SERVICE BULLETIN #1156

SUBJECT STARTER ASSEMBLY, P/N 55129C

MODEL 1-62, 1-82, 1-85 DATE 1-16-62

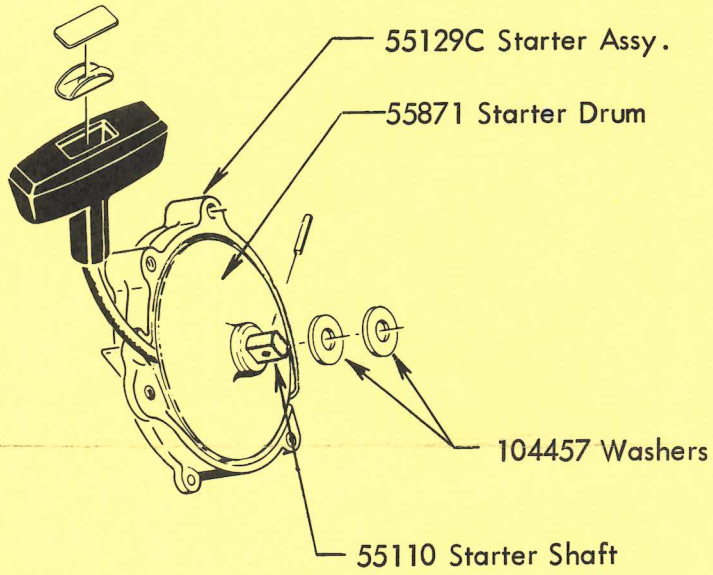
Due to an inadvertent shift in dimensional tolerances between the Starter Drum, P/N 55871, and the Starter Shaft, P/N 55110, a limited quantity of Starter Assemblies, P/N 55129C, were assembled with a second Washer, P/N 104457, installed under the roll pin.

If the second washer is not in place, the ratchet end of the starter shaft may possibly bottom on the clutch rotor assembly.

Thus, when servicing the starter assembly, carefully check the number of washers used and replace accordingly.
